Braidwood Station, Units 1 and 2
Facility Operating License Nos. NPF-72 and NPF-77
NRC Docket Nos. 50-456 and 50-457

Subject: Additional Information Supporting Braidwood I3R-04, Request for Relief from 10 CFR 50.55a(g)(6)(ii)(E), Reactor Coolant Pressure Boundary Examination Scheduling Requirements in accordance with 10 CFR 50.55a(a)(3)(i)

ATTACHMENT
Relief Request I3R-04 Response to Request for Additional Information

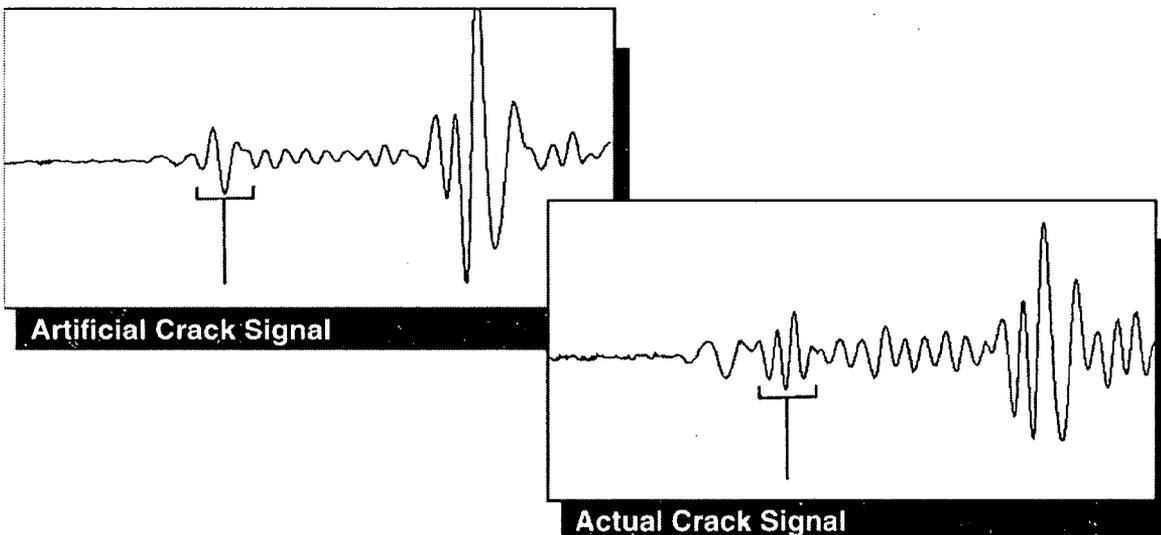
- a) Please characterize the flaw population distribution for the mockups (i.e., range of flaw length and depth, orientation, and types)?
- b) What types of implants were used to generate flaws?

- c) If cold isostatic processing (CIP) flaws were used in the mockups, please provide information on the degree of squeezing during the CIP process and whether the squeezed notches are representative of SCC. Please provide the radius of the CIP flaw tips or a direct comparison with flaws used by Performance Demonstration Initiative in Appendix VIII qualifications, and any reports that compare the response of the flaws used in the mockups with the responses from SCCs.
- d) Did the mockups have any flaws that are representative of fabrication defects? Please provide information on how the UT examiners know the difference between indications from a service induced defect and a fabrication defect.
- e) Do the mockups include a lack of fusion at the weld/tube interface?

- a. Most of these mockups are still considered blind so the flaw distributions cannot be provided in these responses. The mockups are full-scale with as-built weld geometries and have realistic distortion as caused by the J-groove weld. The flaws range in depth, length, and orientation. The mockups used for the capability study have more than 30 realistic flaws implanted in them, as documented in References 1 and 2.
- b. The implants are cold isostatic press (CIP) squeezed EDM notches in the tube.
- c. Typically the radius of the squeezed CIP notch tips used in CRDM and BMI flawed mockups are 10 microns, which is smaller than that required by ASME Section XI, Appendix VIII. Additionally, the ultrasonic notch responses have been compared to a primary water stress corrosion cracking (PWSCC) flaw at the Bugey plant, as shown in the figures below and documented in Reference 1.

- d. Fabrication defects were not intentionally implanted in the mockups; however, some mockups contained several actual fabrication defects that were induced during the actual fabrication of the mockups. The vendors' ultrasonic procedures include instructions for evaluating fabrication defects. Service induced flaws are typically planar in nature whereas fabrication indications appear as volumetric responses. Flaws that are seen by circumferential and axial time-of-flight diffraction (TOFD) and the zero degree transducer are considered volumetric in nature and are noted as fabrication defect indications by procedure. Material shared with the vendors to assist them with their procedure improvements and differentiation between fabrication flaws and cracking is located in Chapter 6 of Reference 2.
- e. Lack of fusion was not was intentionally implanted at the weld / tube interface.
